ADDENDUM NO. 1, May 22, 2015
NW 253rd Ave. Improvements at Meek Rd
Project Number 2120550.00
Page 1

RE: NW 253rd Ave. Improvements at Meek Rd
Project No. 2120550.00

FROM: **Mackenzie**
RiverEast Center
PO Box 14310
Portland, OR 97293
1515 SE Water Avenue, Suite 100
Portland, OR 97214
(503) 224-9560

SD2

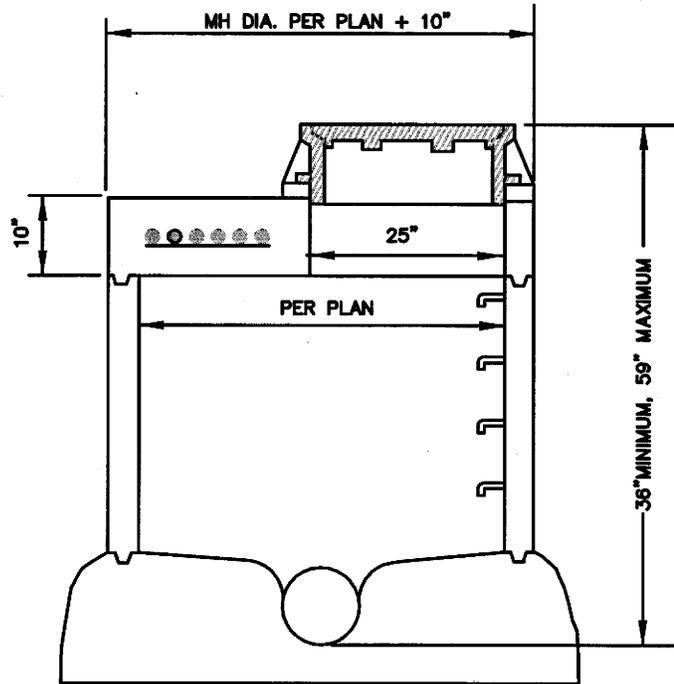
Modifications to detail 3/R8.6 have been reissued as Supplemental Drawings SD2. See attached.

FLAT TOP MANHOLE
(MODIFIED)

SD3

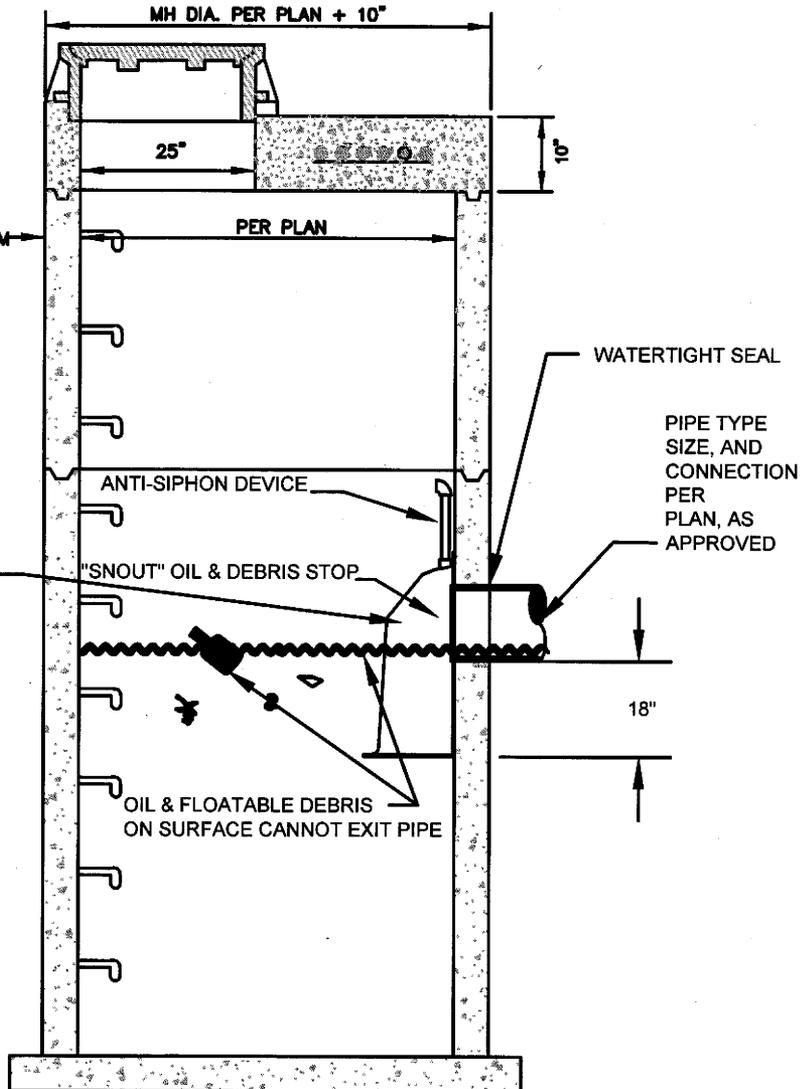
Modifications to detail 1/R8.6 have been reissued as Supplemental Drawings SD3, SD4 and SD5. See attached.

WATER QUALITY MANHOLE (SNOUT) A (MODIFIED)
